Finding of No Significant Impact for the Philadelphia Zoo to Paoli Transmission Line Project

September 2017

**U.S. Department of Transportation,
Federal Railroad Administration
FINDING OF NO SIGNIFICANT IMPACT
Philadelphia Zoo to Paoli Transmission Line Project
Philadelphia, Montgomery, Delaware, and Chester Counties, Pennsylvania**

TREE PRUNING SITE PLAN

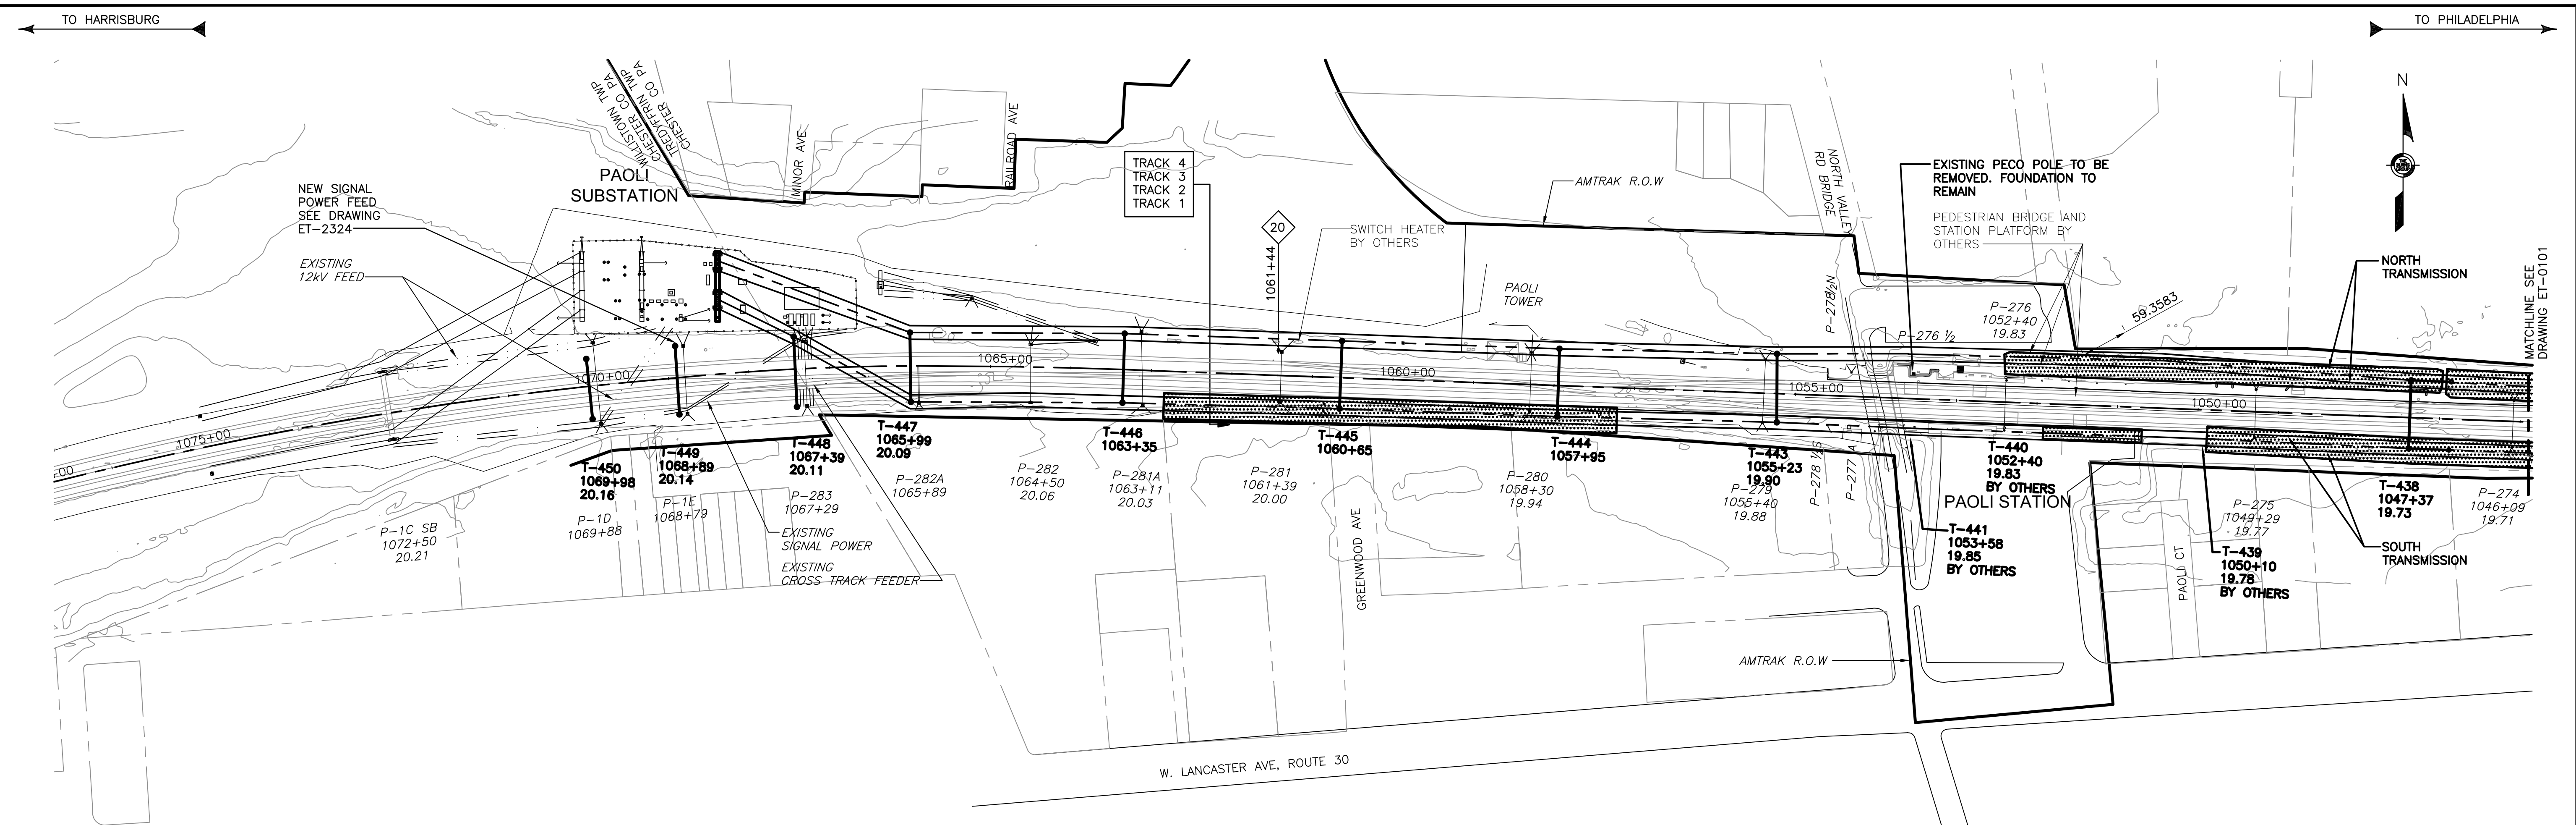
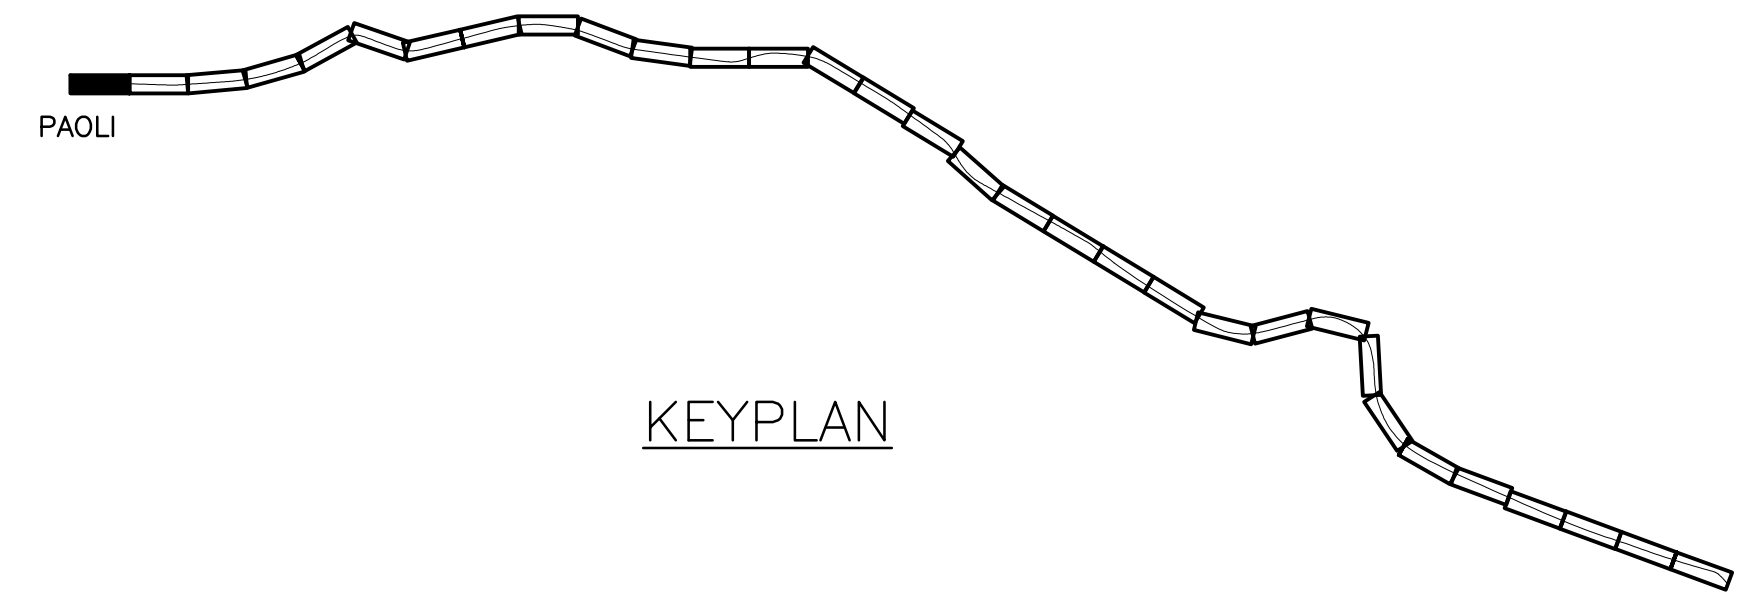
When reviewing the "Tree Pruning Site Plan," I was particularly interested in Notes 2 and 5 on Page C-0200. Having lived at this location for nearly 33years, we have experienced many AMTRAK tree pruning sessions over the years. Our experience has been the opposite of Notes 2 and 5.

Response 4: The project team is sensitive to access concerns and notes the need for prior contact to property owners adjacent to the proposed project. The tree trimming will be monitored in accordance with the contract plans. The construction contractor's team will also include an arborist to direct trimming activities. Tree trimming plans are included in Appendix C of the Environmental Assessment as drawings C-0200 through C-0232 of the Paoli to Bryn Mawr plans and drawings C-0217 through C-0232 of the Bryn Mawr to Zoo plans. The Environmental Assessment and plans are available on the project website at <https://www.fra.dot.gov/Page/P0810>.
